STEPS NECESSARY TO MODIFY SCR 508/608 FOR RECEIVER AUDIO SELECTION

MODIFICATION FOR SCR 508 AND 608 RADIO EQUIPMENT

RE 43F 513B

DETAIL "B"
TOP SIDE FOUNDATION-CENTER

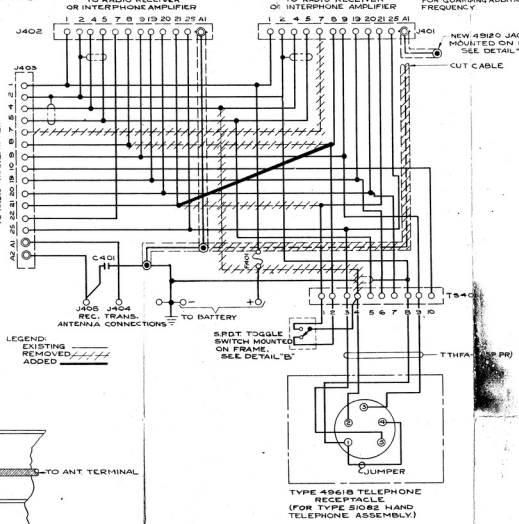
1. REMOVE LEAD (WHITE WITH RED-BROWN TRACER) BETWEEN J401 PIN 7 AND J403 PIN 7.
2. REMOVE LEAD (WHITE WITH RED-GREEN TRACER BETWEEN J402 PIN 21 AND J401 PIN 21. RETAIN LEAD (WHITE WITH RED-GREEN TRACER) BETWEEN J401 PIN 21 AND TS401 TERMINAL 1.
3. CUT LEAD (WHITE WITH BROWN TRACER) BETWEEN J402 PIN 8 AND TS401 TERMINAL 2. SPLICE THIS LEAD TO THE LEAD REMAINING ON J402 PIN 21 (WHITE WITH RED-GREEN TRACER) SO THERE IS CONTINUITY BETWEEN J402 PIN 21 AND TS401 TERMINAL 2.
4. MOUNT S.P.D.T. TOGGLE SWITCH IN RIGHT HAND CABLE KNOCK-OUT ON FRONT OF MOUNTING FT-237.
5. CONNECT TS401 TERMINAL 1 TO ONE SIDE OF SWITCH AND TS401 TERMINAL 2 TO OTHER SIDE OF SWITCH. CLIP AND TAPE LEAD ON TS401 TERMINAL 4 AND RUN LEAD BETWEEN THIS TERMINAL AND POLE OF TOGGLE SWITCH.
